HIDEOUT, UTAH PLANNING COMMISSION PUBLIC HEARING AND SPECIAL COMBINED TOWN COUNCIL / PLANNING COMMISSION WORK SESSION

June 02, 2022

Staff Review of Plan Submittal

Staff Report for the Boulders – Development Agreement Review and Rezone Request

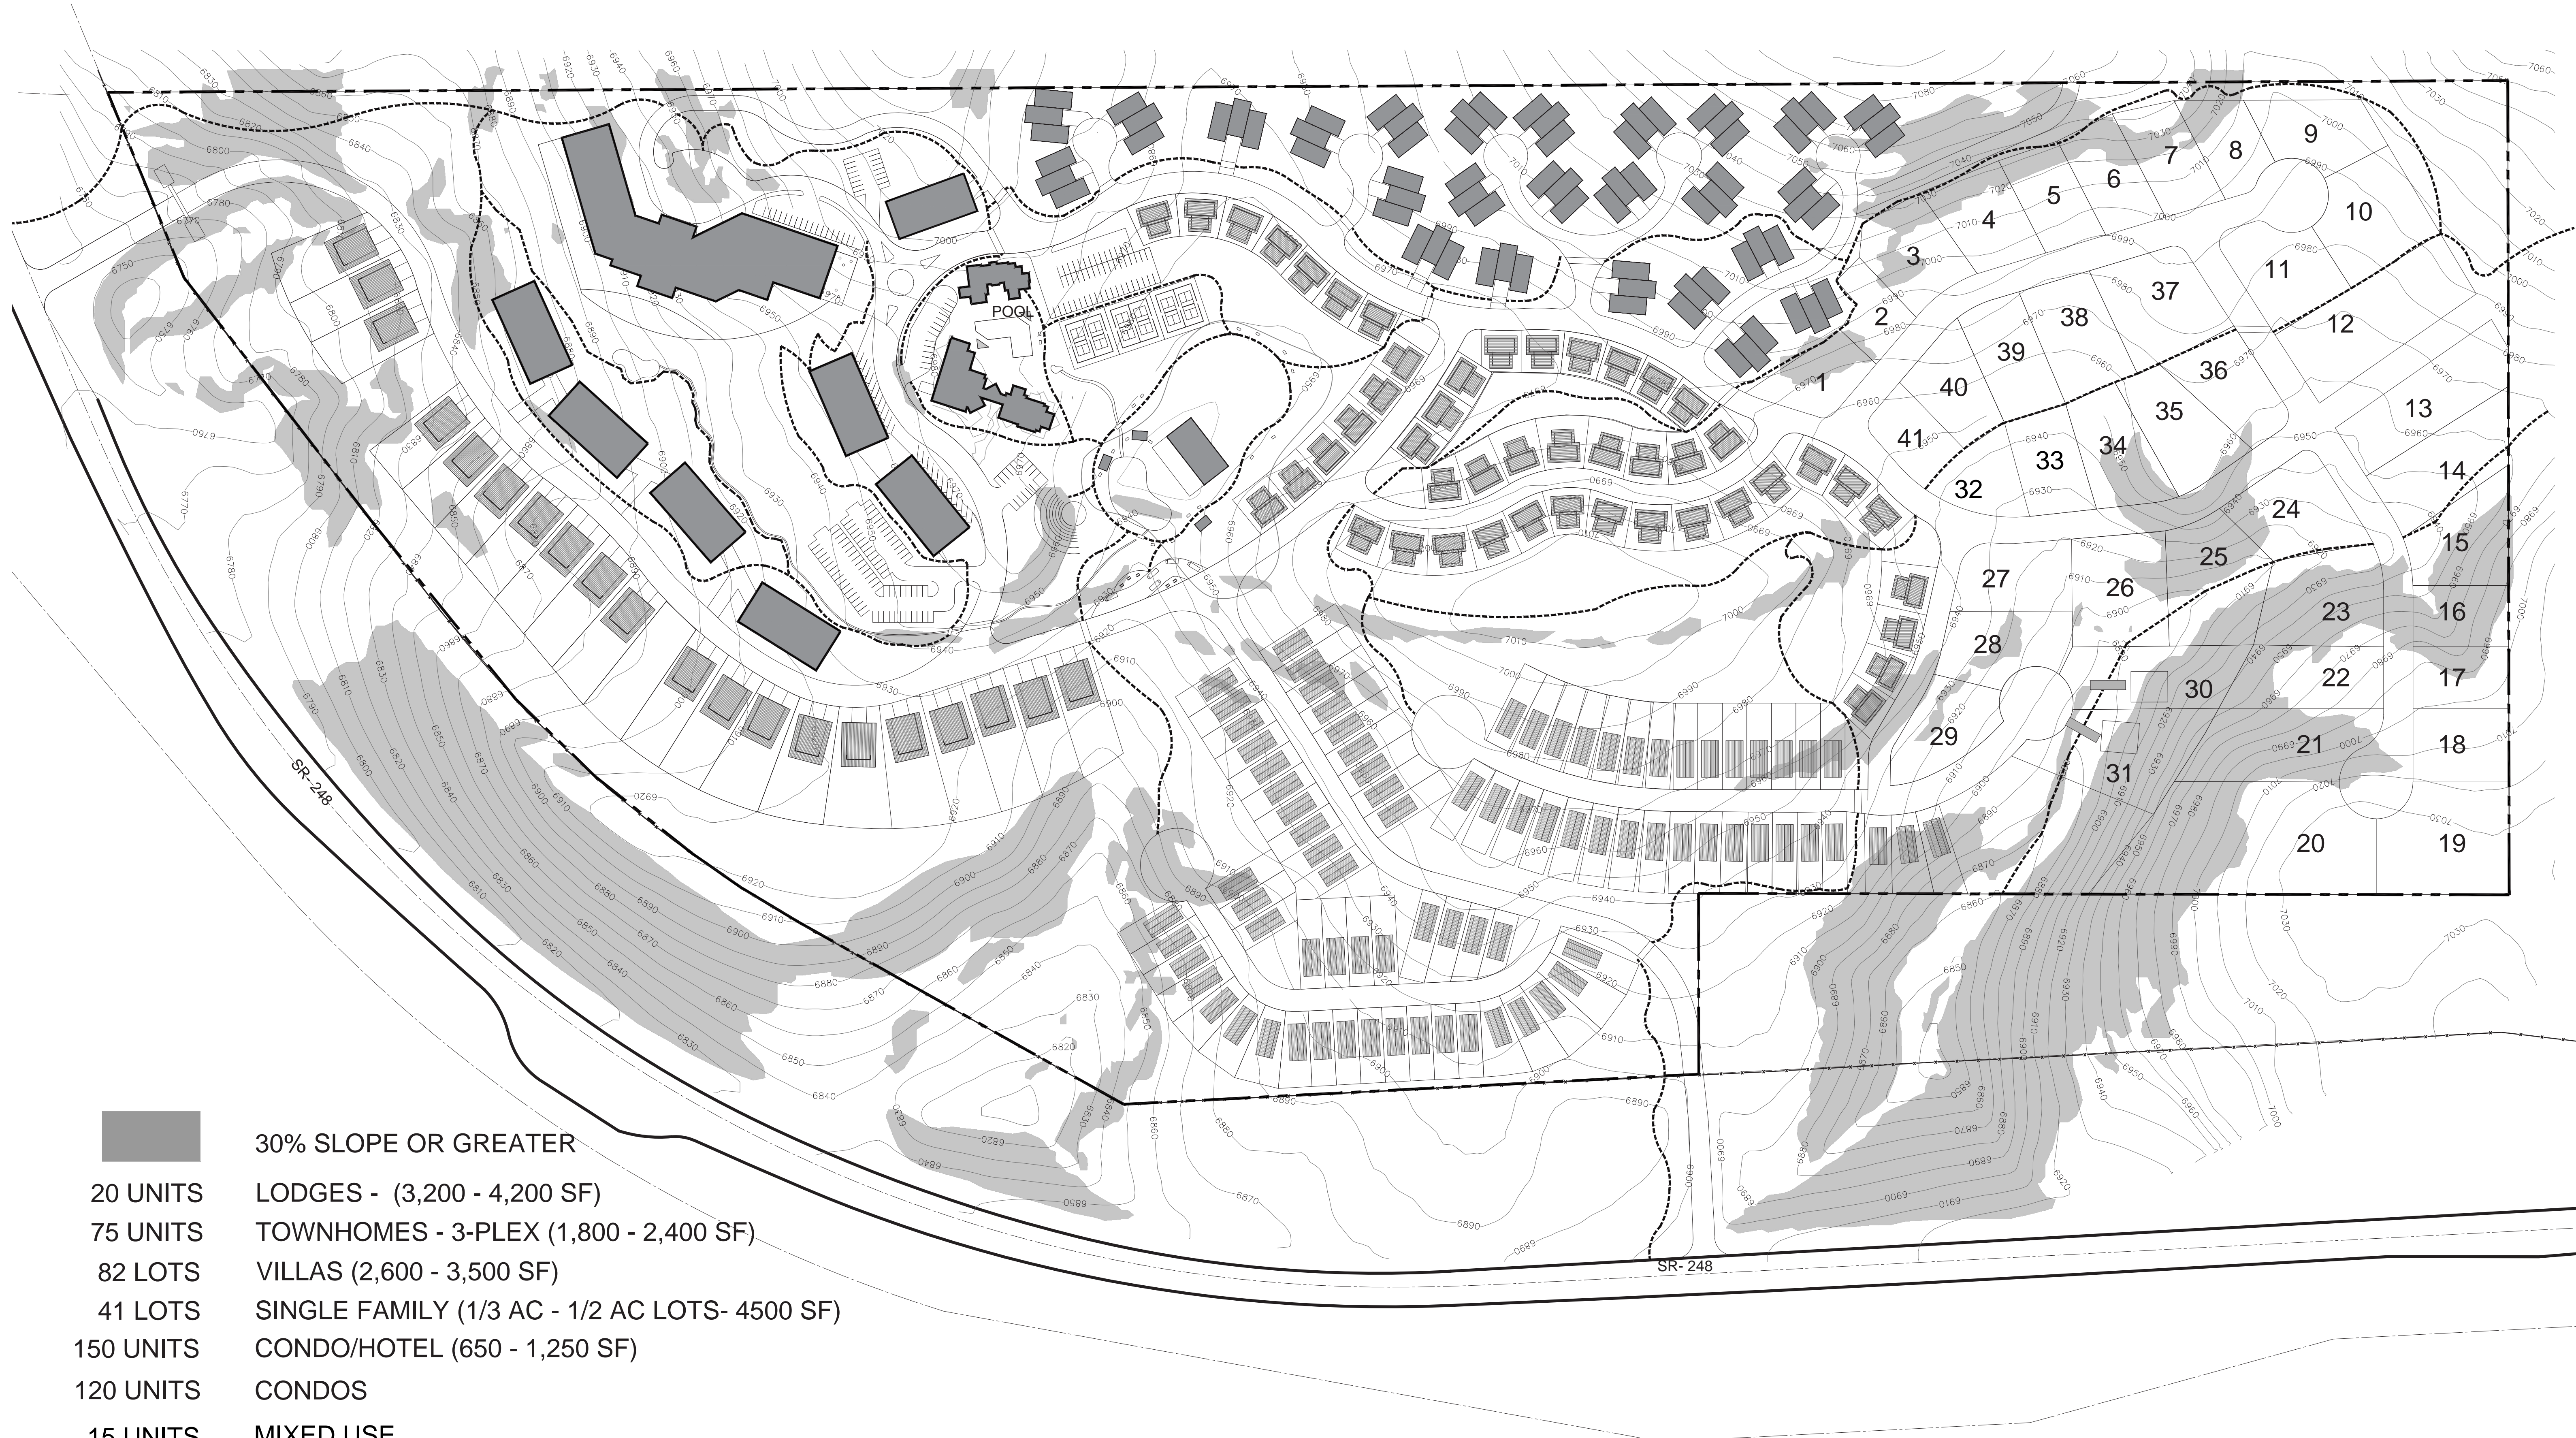
10. Connectivity to Nearby Neighborhoods

- a. The Applicant shall explain the proposed connection to Golden Eagle and the entrance road to Golden Eagle.

OPEN SPACE

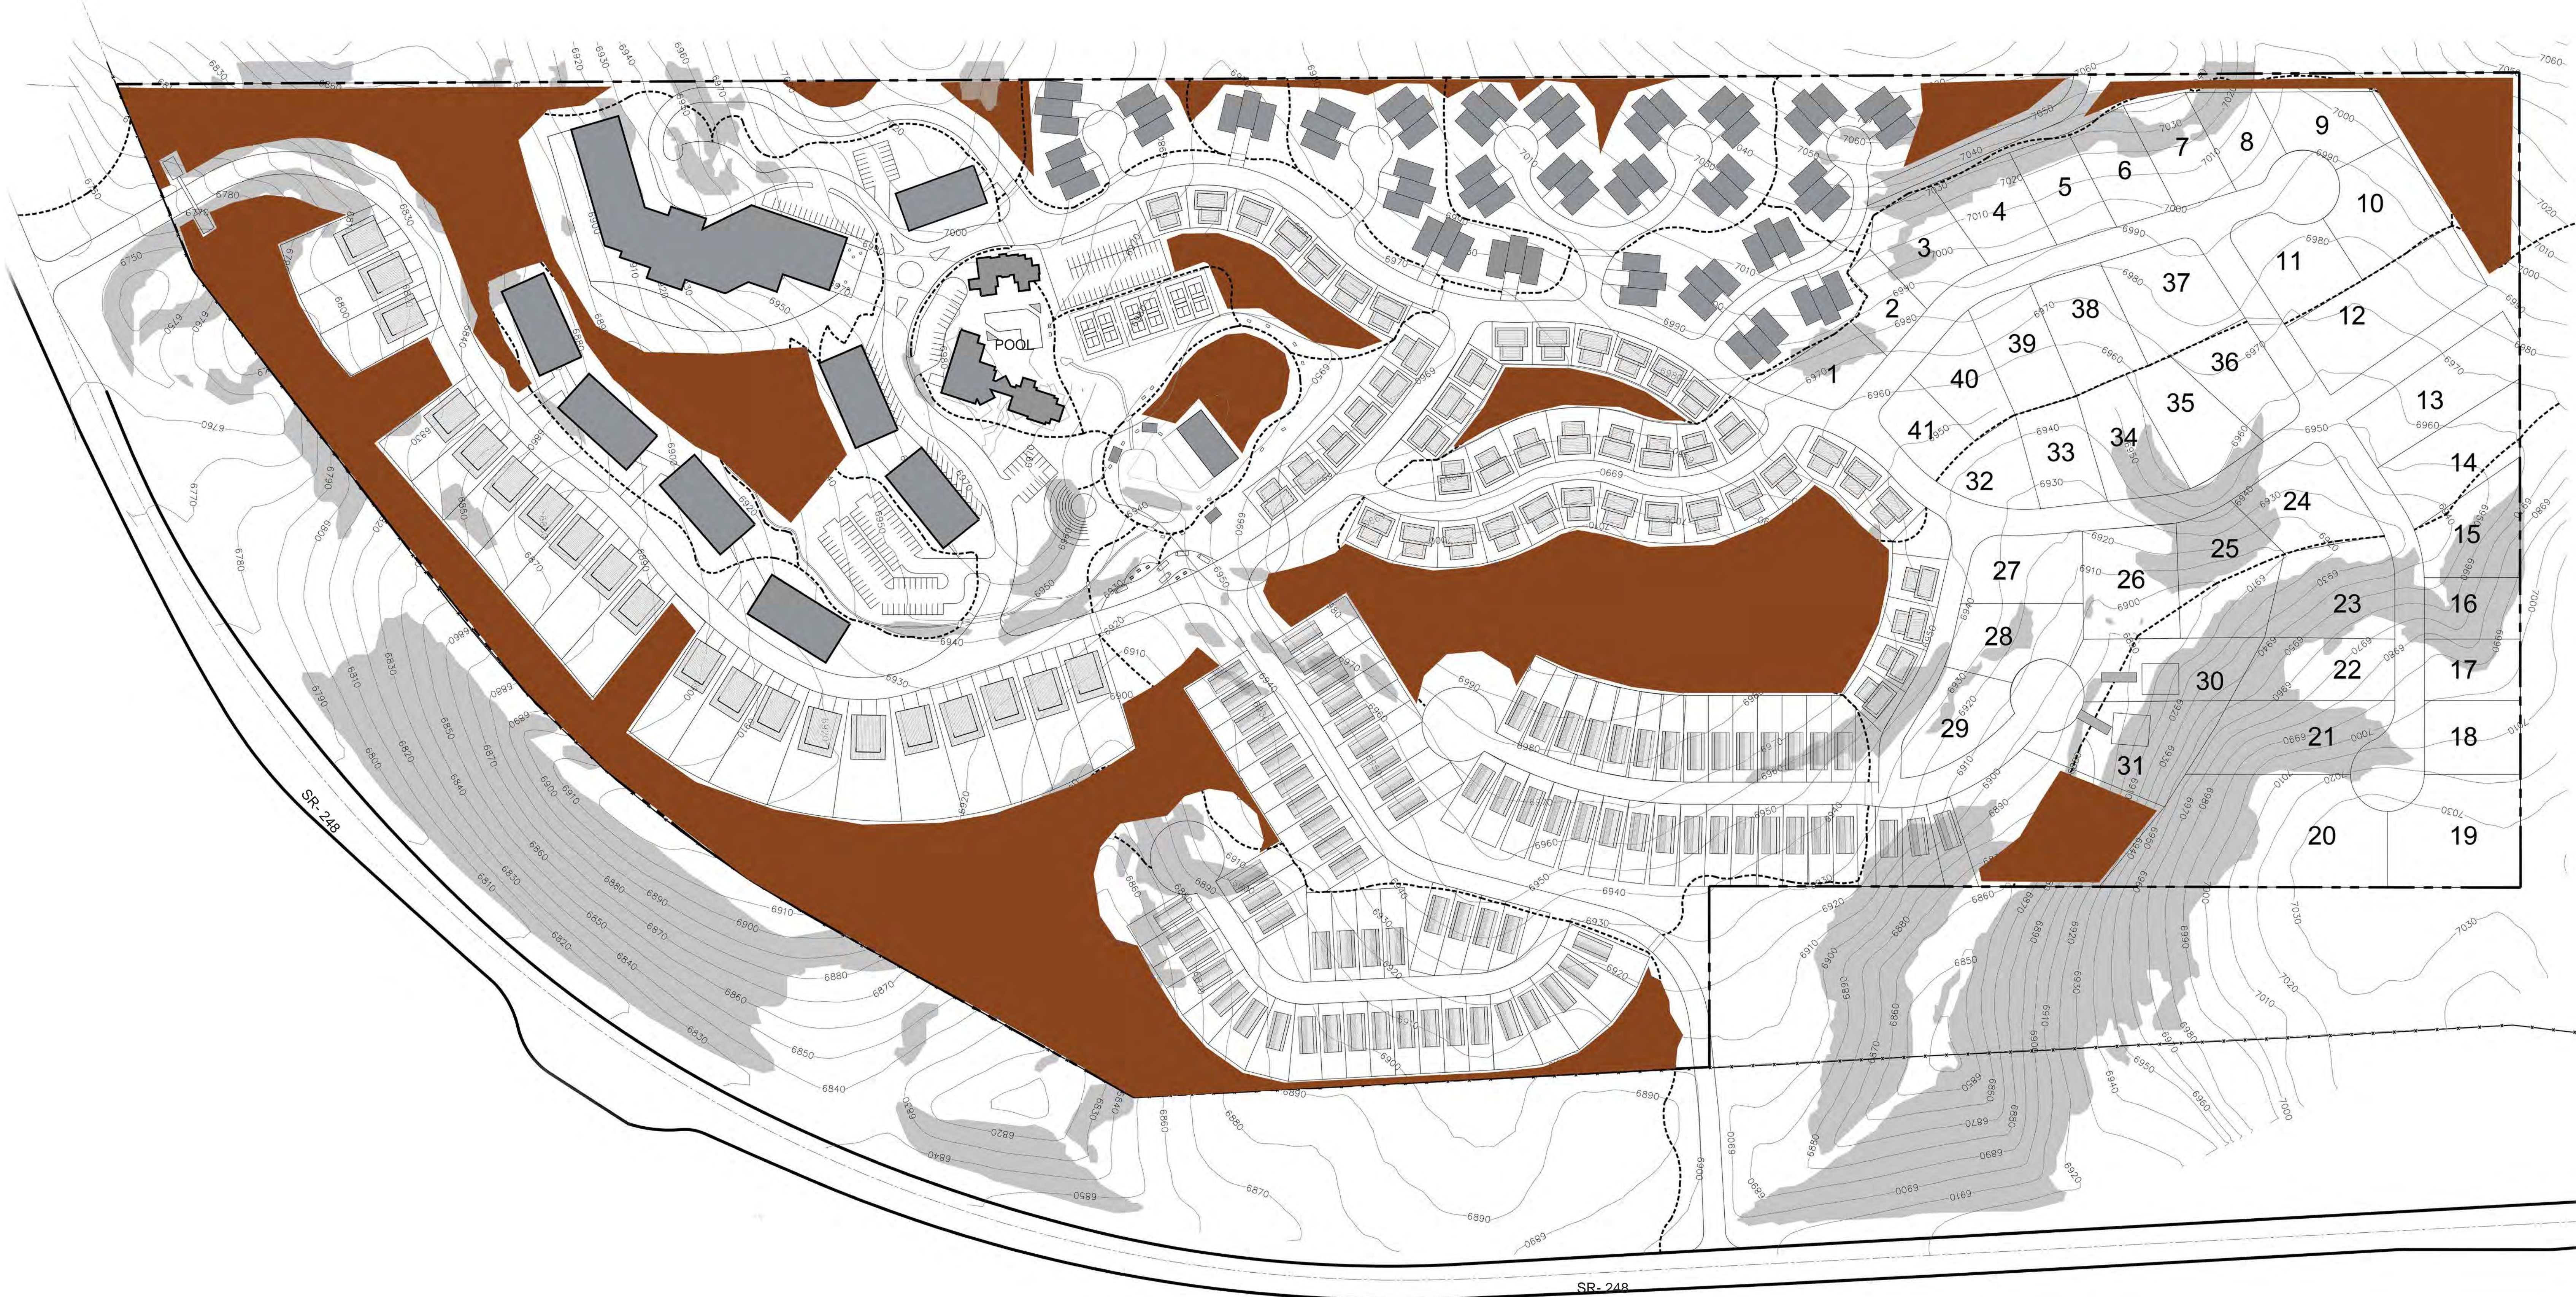
9. Undisturbed Land

- a. A minimum of 45% of the total (gross) site was proposed as undisturbed to the Planning Commission.
- b. Updates to the preliminary grading plan have seen this reduced to 5% – 15% of the site as undisturbed.

- a. The Planning Commission must provide input regarding the maximum amount of land disturbance permitted. Recent projects, Shoreline Phase 3 and Lakeview, with the densities proposed, required an almost complete denuding of the sites to accommodate development.

- c. This value must be defined numerically in the MDA
- d. 'Undisturbed land' must be defined in the MDA
- e. Areas to remain undisturbed must be illustrated on a site plan and included in the MDA.
